Amendments to the Drawings:

Application No. 10/787,338
Office Action dated Mar. 21, 2006
Reply to Office Action dated Jun. 21, 2006
Annotated Sheet Showing Changes

FIG26B

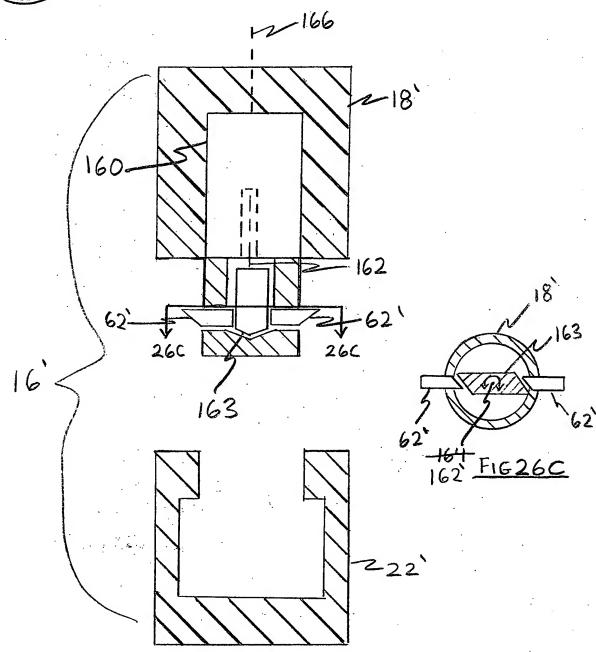
In addition, Figure 26C has been amended to correct a duplicate reference character 164, now 162', in accordance with the amended specification.

FIG28A

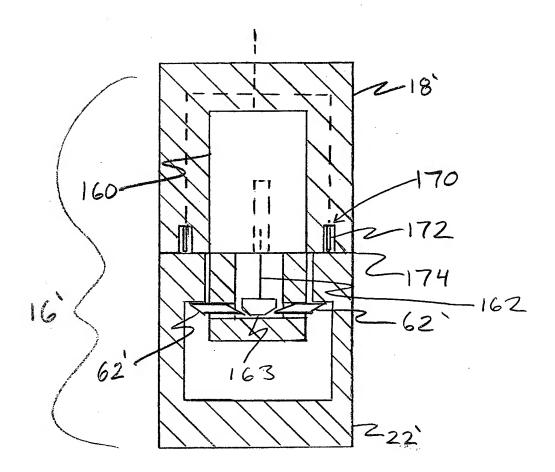
Finally, Figures 28A and 28B have been amended in include reference characters 162 and 163 as identified in the specification, which were inadvertently not included in the original drawings.

FIG29

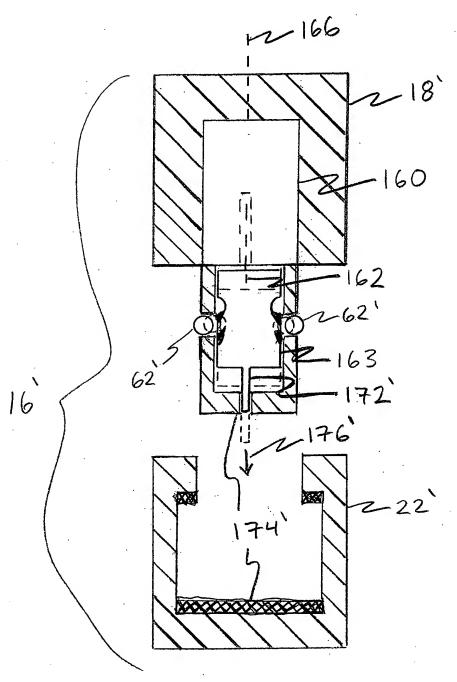
As illustrated on the Annotated Sheet, Figure 29 has been amended to illustrate the inner portion of second component 22' comprising a greater longitudinal dimension to allow for extension of propulsion member 172', and enlargement of the channel in element 162 to engage locking members 62' concurrent with the extension of the propulsion member 172', such that the first component 18' and the second component 22' are detachable.

Also, Applicant has amended Figure 29 to illustrate the inner portion of the second component 22' comprising a greater longitudinal dimension to allow room for extension of propulsion member 172' and enlargement of the channel in element 162 to engage locking members 62' concurrent with the extension of the propulsion member 172', such that the first component 18' and the second component 22' are detachable. As such, Applicant believes the objection to Figure 29 is fully addressed and, further, that the objection to the specification is now moot in view of amended Figure 29.
